PSE&G Public Service
Electric and Gas
Company

HOPE CREEK GENERATING STATION
DOCKET NO. 50-354
DRAFT SAFETY EVALUATION REPORT
OPEN ITEM STATUS

In addition, enclosed for your review and approval (see Attachment 4) are the resolutions to the Draft SER open items listed in Attachment 3 and revised FSAR Sections 1.8.1.26, 6.2.5.2.5, 7.6.1.4.3, and Figure 8.3-16. A signed original of the required affidavit is provided to document the submittal of these items.

FIGURE 8.3-16

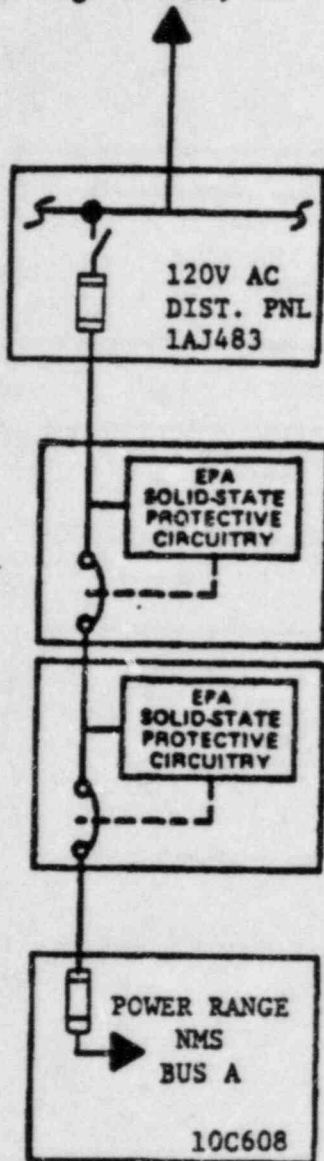
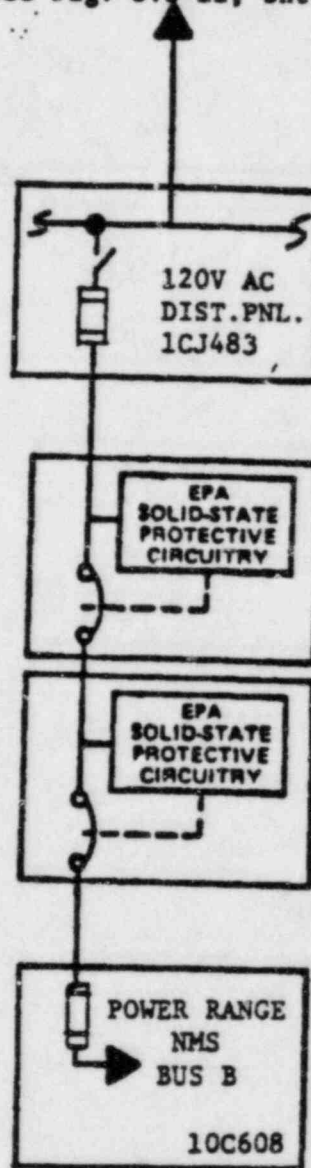
Electrical protection assemblies (EPAs) identical to those used in the reactor protection system (described in Section 8.3.1.5.4) are installed between the power range NMS and each of the two 120V ac feeders from the UPS power sources (see Figure 8.3-16).

The EPAs ensure that the power range NMS never operates under degraded bus voltage or frequency conditions. The power range NMS panel (10C608) was analyzed with this power supply configuration to ensure that no single failure of the power range NMS could jeopardize the safe shutdown of the plant.
